## **Opsiynau llwybr Teithio Llesol o'r Barri i Ddinas Powys**

### **Adroddiad ar yr Ymgynghoriad**

## Opsiwn llwybr 1

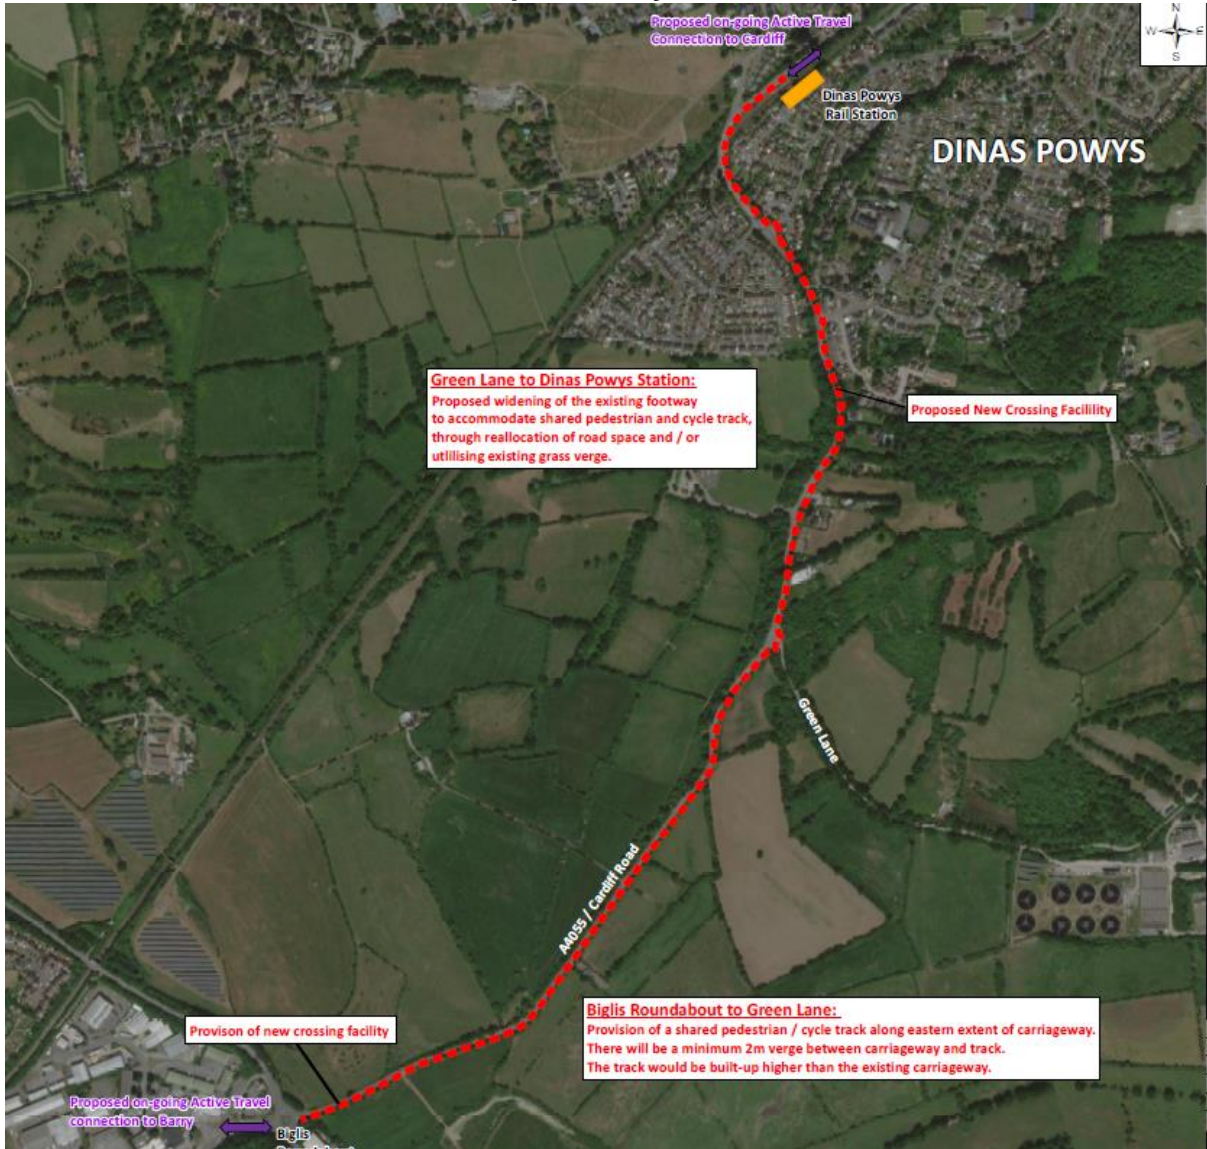
- Pryderon am gael gwared â gwrychoedd ac effeithiau ar fywyd gwylt.
- Mae'r llwybr ochr yn ochr â thraffig.
- Mae'n llwybr uniongyrchol.

<b>Comment received from the public</b>	<b>Council response</b>
1	Direct and street lighting would be better	Lighting of an active travel route would be looked at during future design stages.
2	Most direct route... and most feasible?	Thank you for your comment.
3	You must be mad, The Road isn't wide enough as it is.	If this is the preferred route, then highway widths would be looked at during the next stage of design.
4	I'm not exactly sure where this route is, I'm very supportive as currently there is no safe way to get from Barry to Dinas either on foot or by bike. My only concern is if it's not clearly separated from any motor vehicles it really would be dangerous	Thank you for your support of an active travel route here.
5	A shared cycle and walkway makes it unusable for commuting unless fully segregated which would push cyclists back onto the road or into cars.	A segregated route will look to be provided if there are sufficient widths.

6	Disruptive to traffic on Cardiff Rd during construction	This would be unavoidable but access would be maintained as much as possible.
7	Walking and cycling next to busy traffic is not appealing.	Noted. The other route options offer routes away from traffic.
8	Would worry about speeding cars on Cardiff Road if I were cycling	A buffer separating the AT provision from the highway would be provided as per AT guidance.
9	Needs to be clearly separated and safe from traffic with clear delineation from adjacent pedestrian walkway	Noted and your comment will be considered at the next stage of design.
10	Provide bins	The provision of bins will be discussed with the cleansing department if the route is constructed.
11	I have lived in Dinas powis for most of my life and this has been needed for a long time. When I worked in Barry I would have cycled to work but the road was far too dangerous. Let's hope this can go ahead and make it a pleasurable experience not a nightmare.	Thank you for your support of an AT route.

## Opsiwn llwybr 2

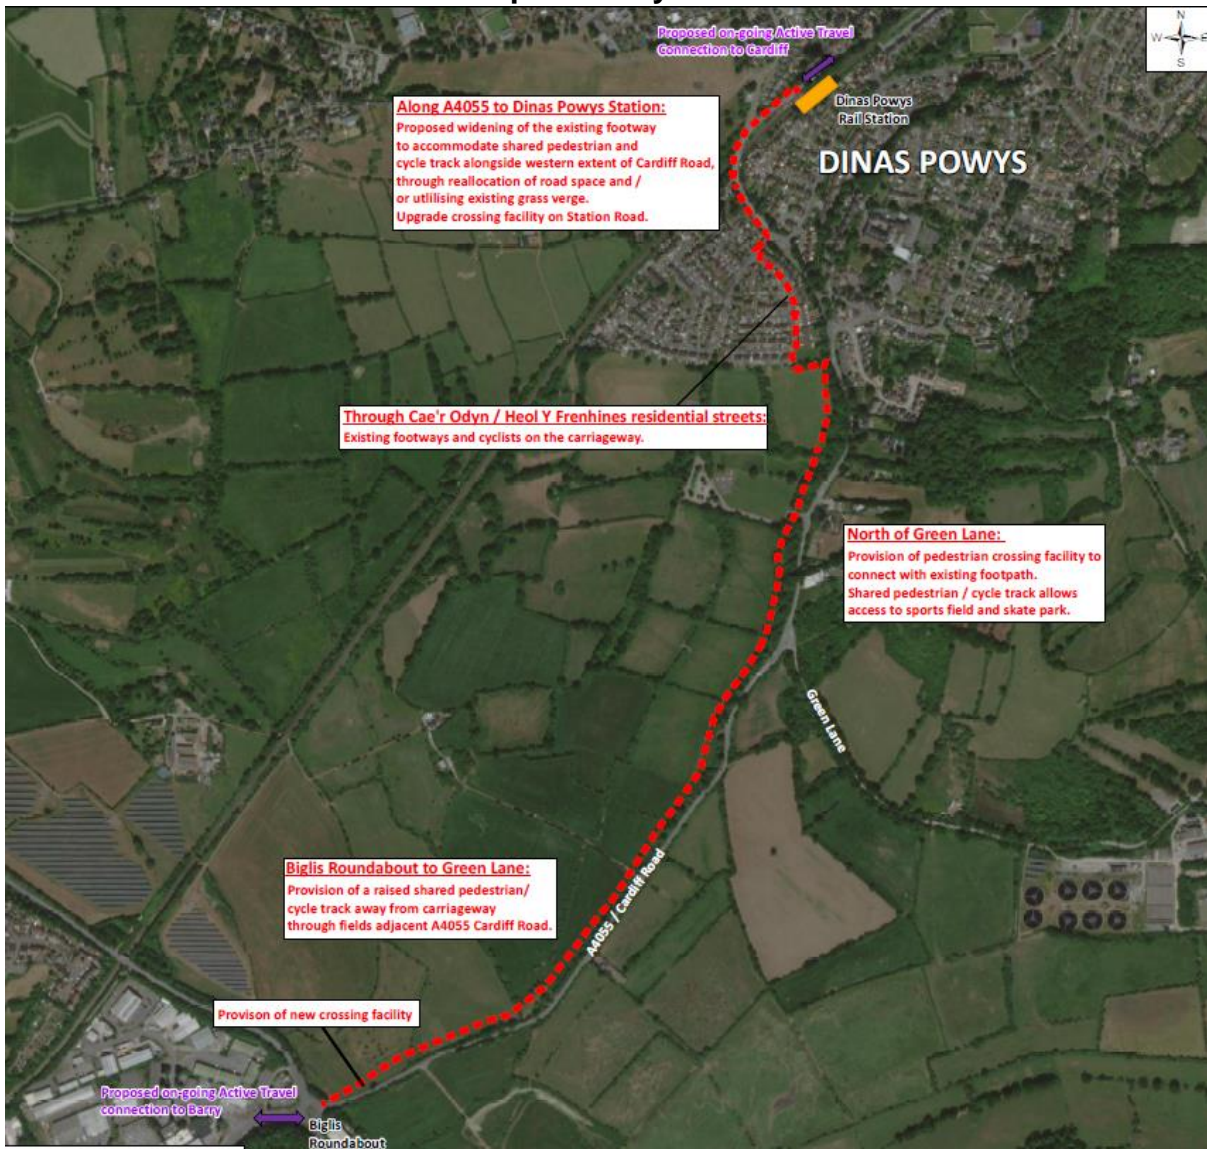
- Pryderon am lifogydd yn yr ardal.
- Pryderon am draffig ym mynd drwy strydoedd preswyl.
- Hoffi ei fod i ffwrdd o draffig mewn mannau.

<b>Comment received from the public</b>	<b>Council response</b>
1	This route is liable to regular flooding	We are aware of the flooding in this area and we would undertake full flood modelling at the next stage of design.
2	Will make the estate of Southra congested as existing footways are not large enough. Also removes elements of the playing field, and may also increase ASB which is currently a problem	Should a route be directed through the Southra estate then we would look to improve conditions for pedestrians. Discussions with Safer Vale and SWP would take place to discuss ASB implications of any route taken forward to the next stage of design.
3	Least biodiversity impacts on hedgerows, woodland and scrub. Least operational impact on Cardiff Road and take the least amount of time to construct. BUT not a direct route.	Thank you for your comments that will be considered when choosing the preferred route for the next stage.

4	Very concerned about flooding and how safe it would be in the dark	Lighting of any AT route is considered at the next stage of the design process.
5	An off-road route is the only sensible route.	Thank you for taking part in this consultation and choosing your preferred route.
6	This route is my favoured option out of the 3, but how high to make the path to accommodate flooding and for future with climate change if the water does rise further, also is this option more expensive ?	Thank you for your input. There will be extensive flood modelling and discussions with NRW whichever route is taken forward.
7	Flood risk	There will be extensive flood modelling and discussions with NRW whichever route is taken forward.
8	Most of the route is away from the busy road so would be a pleasant route. The last part that joins Cardiff Road does not appeal, even with an improved crossing, there would need to be other measures such as a 20mph speed limit/cameras as speeding is common here.	More detail on how the route would join Cardiff Road would be provided at the next stage of design consultation.

### Opsiwn Ilwybr 3

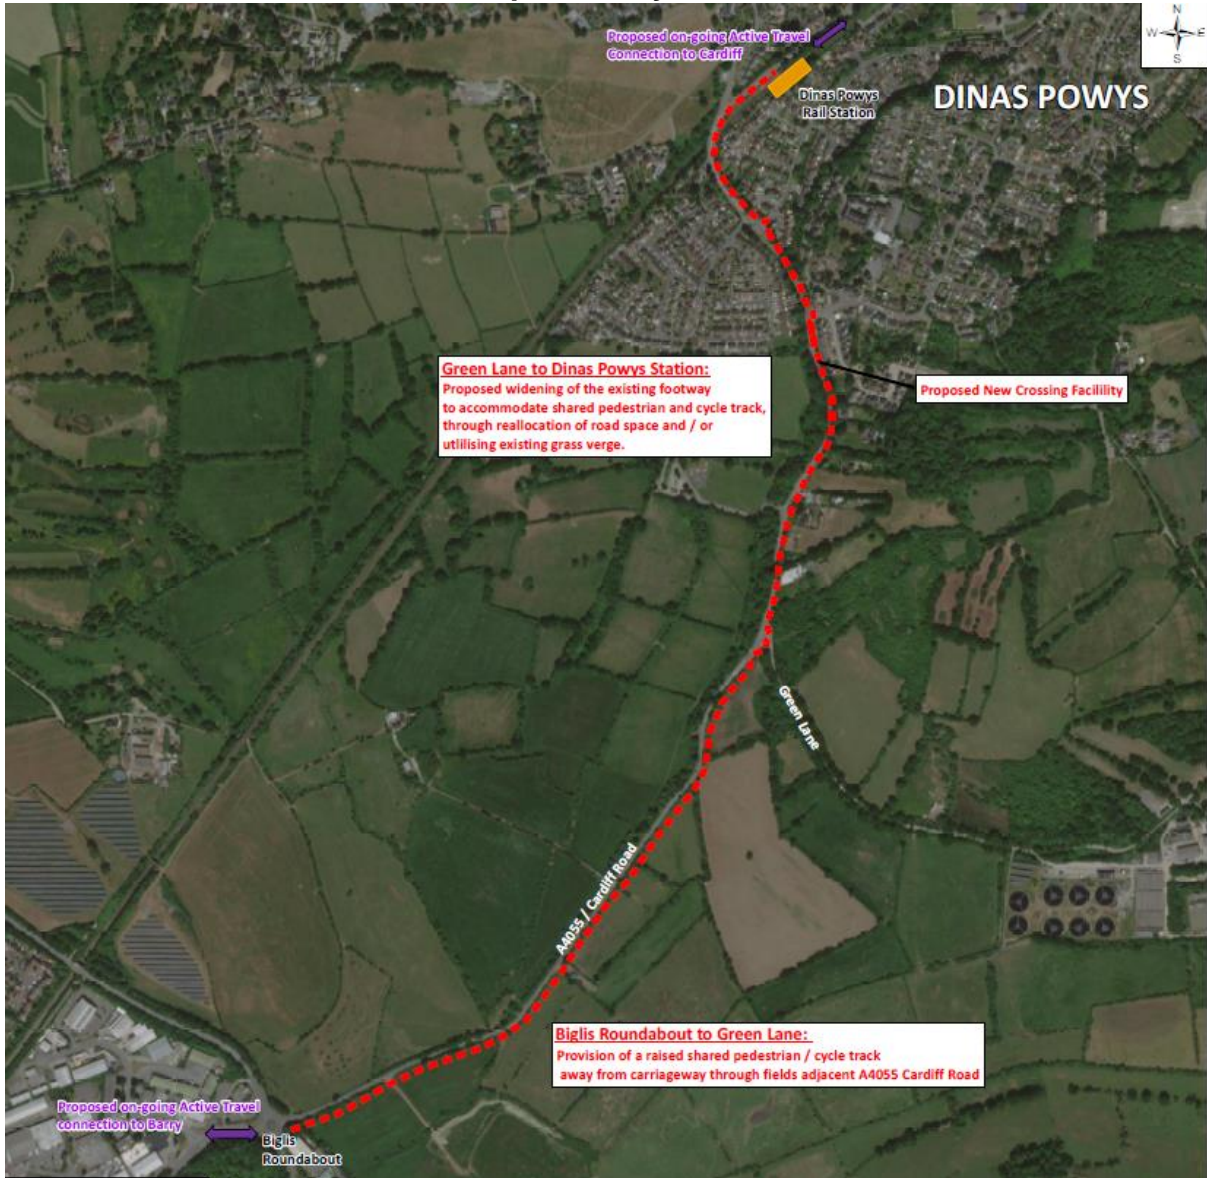
- Mae'n well gan ei fod i ffwrdd o draffig.
- Pryderon ynghylch goleuadau a llifogydd yn ystod misoedd y gaeaf.
- Yr effaith amgylcheddol leiaf o blith y llwybrau a ddangosir.

<b>Comment received from the public</b>	<b>Council response</b>
1	Better option, least impact.	Thank you for taking the time to respond.
2	Veey concerned about flooding, smells from bearby sewage and safety of the route for vulnerable users	All of the points you've raised would be looked at during the next stage of design, depending on which route is taken forward.
3	An off-road route is the only solution	Thank you for your comment.
4	An off-road route is the only solution	Repeat of number 3.
5	Follows main road but with clear segregation	Thank you for your comment.
6	Lesser environmental impact	Thank you for taking the time to comment.
7	Best side of the road, as it better links to Dinas Station and existing path at McDonalds Roundbout.	Thank you for your comment.
8	Cant really see how this differs from route 1	Route option 1 is next to the highways/traffic. Route option 3 is separated from traffic.

## Opsiwn llwybr 4

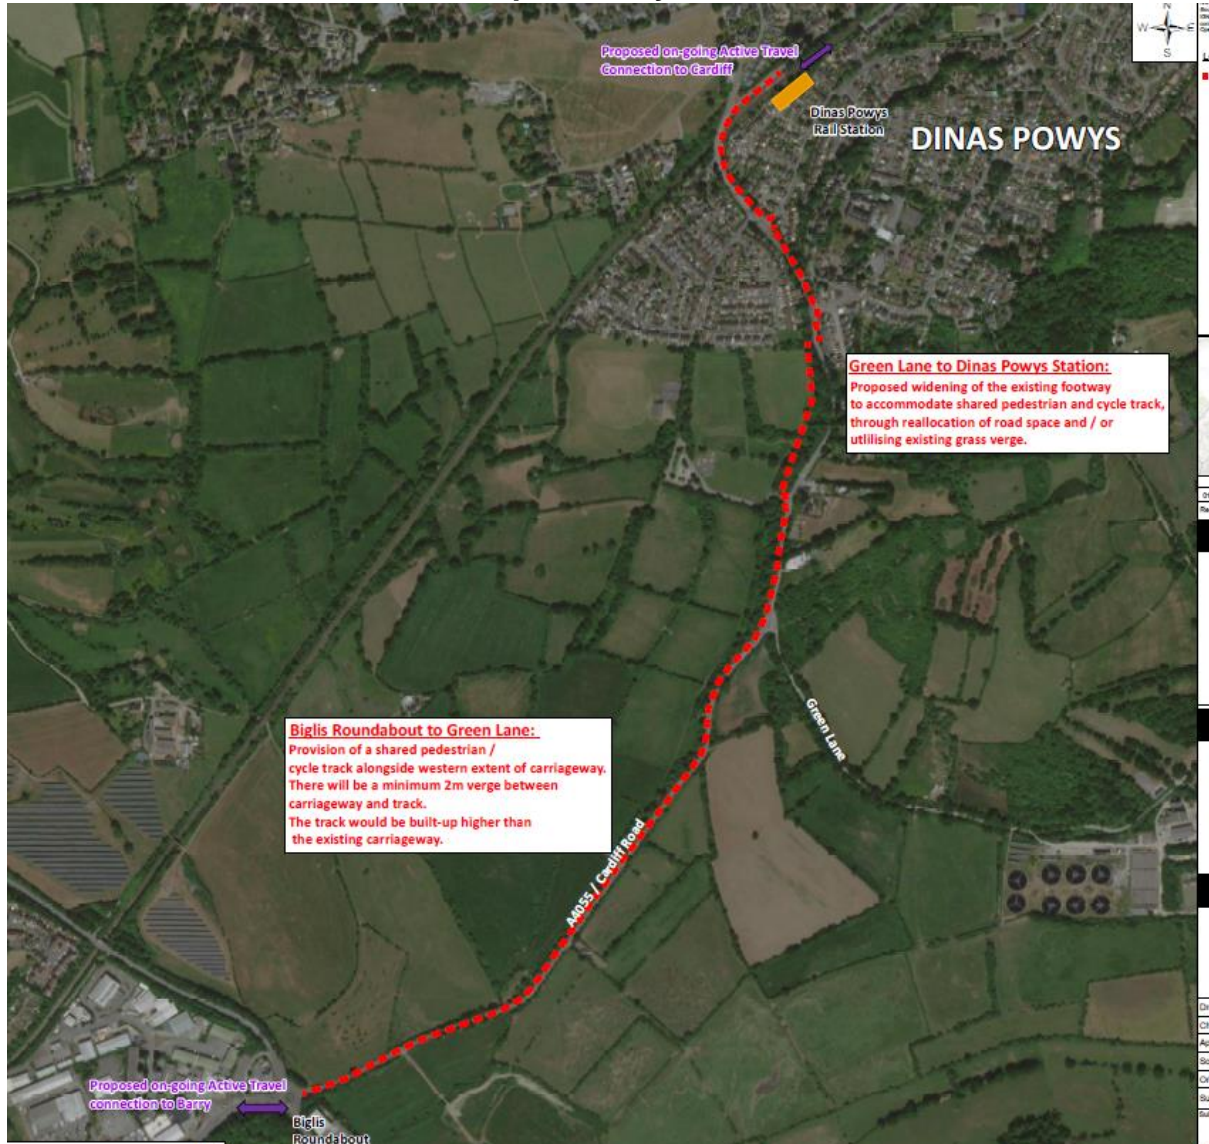
- Ddim yn teimlo mor ddiogel ag opsiynau eraill

<b>Comment received from the public</b>	<b>Council response</b>
1	This is madness in a double whammy The Road isn't wide enough and too dangerous as it is. Crossing the road would cause even more chaos and be much more dangerous. Total madness.	Thank you for your comment. Should this be the route taken forward to the next stage of development then there would be studies into road width and speeds.
2	This is madness in a double whammy The Road isn't wide enough and too dangerous as it is. Crossing the road would cause even more chaos and be much more dangerous. Total madness.	Repeat of number 1.
3	This is madness in a double whammy The Road isn't wide enough and too dangerous as it is. Crossing the road would cause even more chaos and be much more dangerous. Total madness.	Repeat of number 1.
4	This is madness in a double whammy The Road isn't wide enough and too dangerous as it is. Crossing the road would cause even more chaos and be much more dangerous. Total madness.	Repeat of number 1.

## Opsiwn llwybr 5

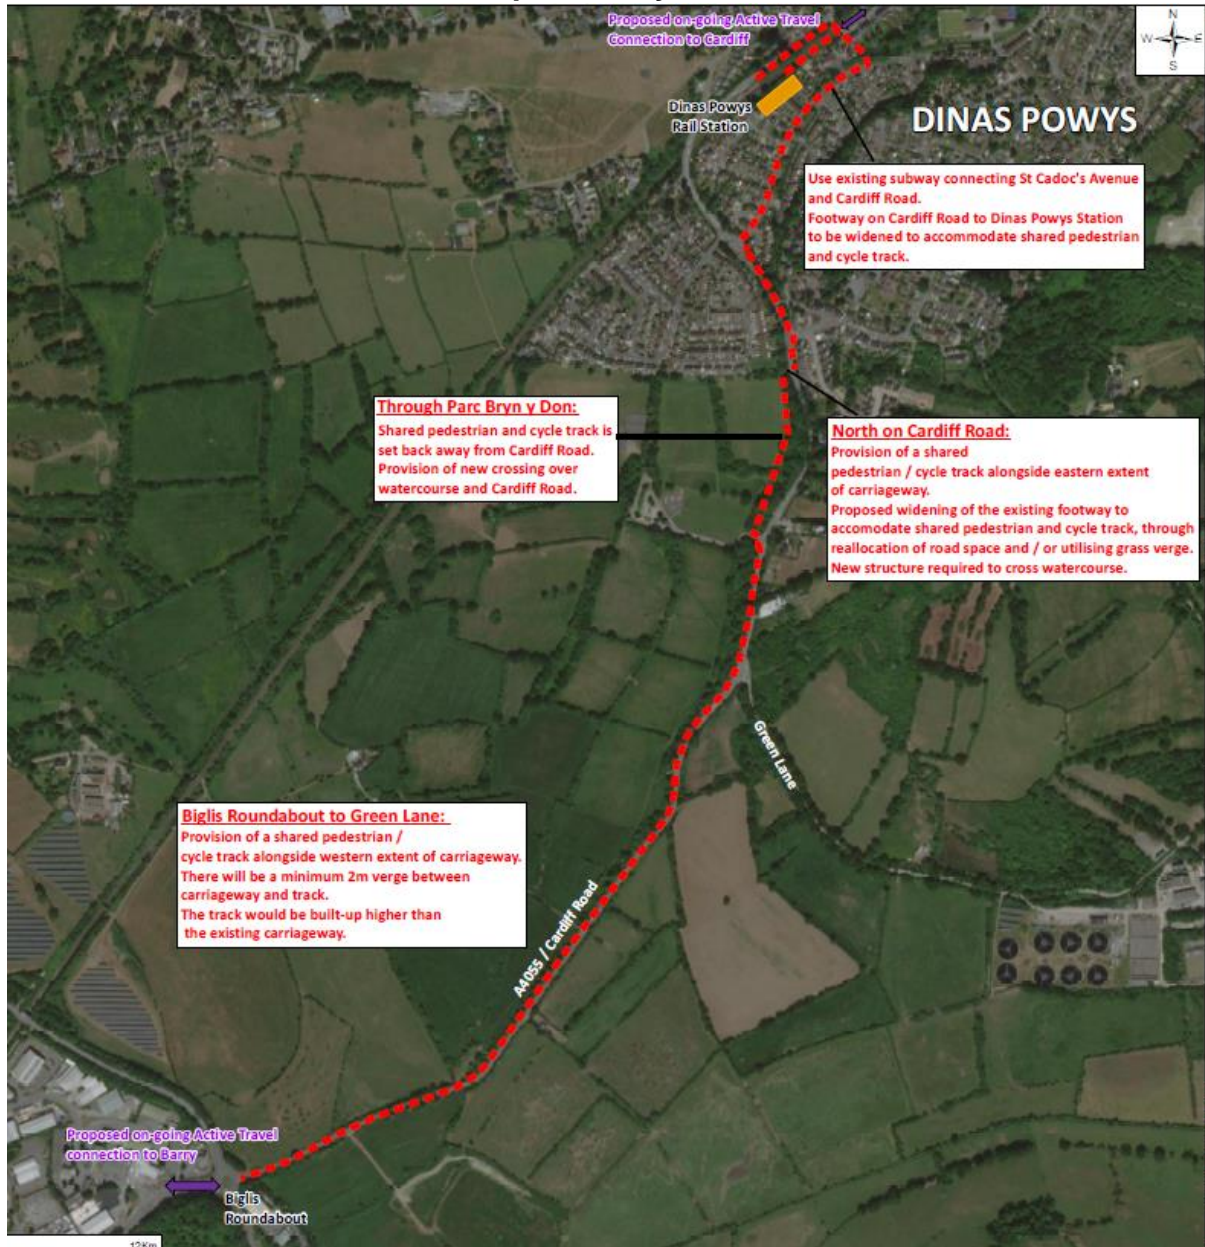
- Byddai'n dod â mwy o draffig i ardal breswyl brysur.

<b>Comment received from the public</b>	<b>Council response</b>
1	Too long, the existing paths in sonnycroft are not suitable or wide enough	Thank you for taking the time to comment. Should this route be taken forward to the next stage of development, widths would be looked at.
2	An off-road solution is the only sensible one	There were off-road options presented as part of this consultation.
3	This would be my least favourite option	Thank you for taking the time to look at all the route options and commenting.
4	Flood risk	There would be considerable flood modelling undertaken at the next stage of design.
5	The last part of this route to the station, staying away from Cardiff Road makes sense.	Thank you for your comment.
6	<p>As a resident just off St Cadoc's Avenue, I would oppose a cycle route here for a number of reasons.</p> <p>It would bring more people traffic to the area which is already a built up busy estate.</p> <p>There are many junctions down the entire stretch of st cadoc's Avenue on both sides and I believe there would be a high risk of accidents from cars pulling out in all directions into the cycle lane.</p> <p>It seems unnecessary longer and more costly to re-route the cycle lane through this estate to the train station when the route could just simply continue along Cardiff road a further 100m to reach the same destination.</p> <p>I would be concerned about the environment impact of the cycle route along St Cadoc's Avenue - there are many green areas, trees, bushes and weeping willows in the street which makes you feel close to nature. A cycle route would change the look and feel of that.</p> <p>Finally, there are many children living on the sonnycroft estate and I feel extra traffic down this street would bring more risks than benefits to them.</p>	Your comments will be considered as part of choosing the route to be developed.
